SUBJECT: Summary of Comments and Questions
Major Development Pre-Application Public Workshop on September 25, 2025
480 Avenue Alhambra, El Granada, CA 94019
APNs: 047-251-100, 047-251-110, and 047-262-010
County File Number: PRE2025-00033

The purpose of this letter is to summarize the comments received during the public workshop and provide comments received from County departments and other reviewing agencies. This letter is for informational purposes only and shall not confer or imply any approval or rejection of the project by the County of San Mateo.

Subject: ***Pre-Application PRE2025-00033 (Granada Community Park and Recreation Center Project)***

Subject: Snapshot
Page Label: 16
Author: scai1
Date: 9/16/2025 1:45:05 PM
Color:

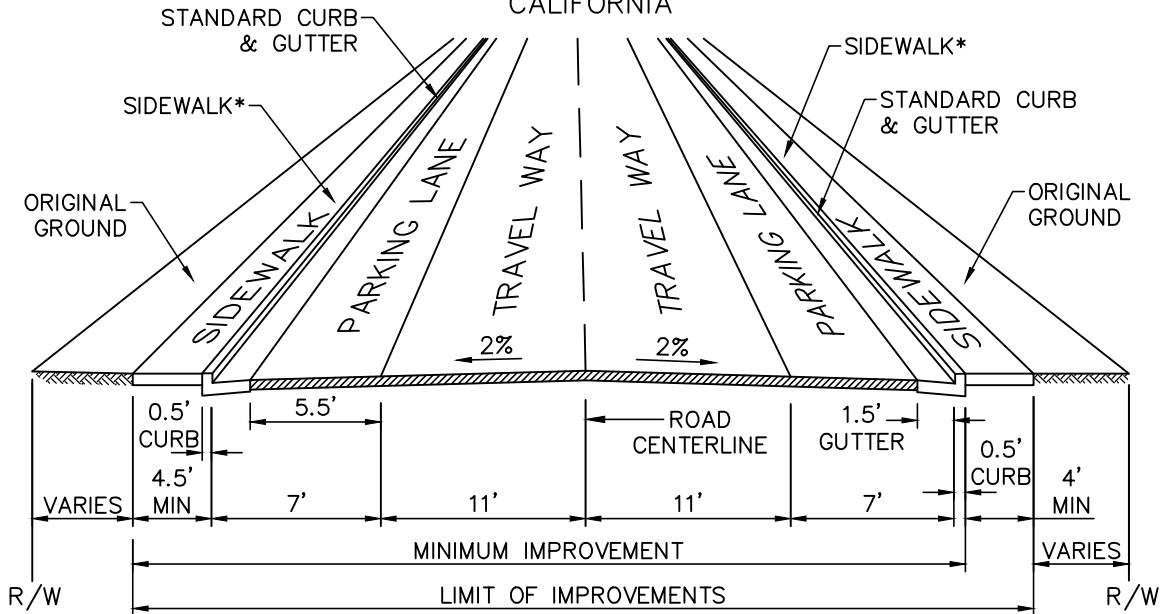
El Granada road standards require 22' paved travel way, parking lane, curb, gutter, and sidewalk. See attached detail
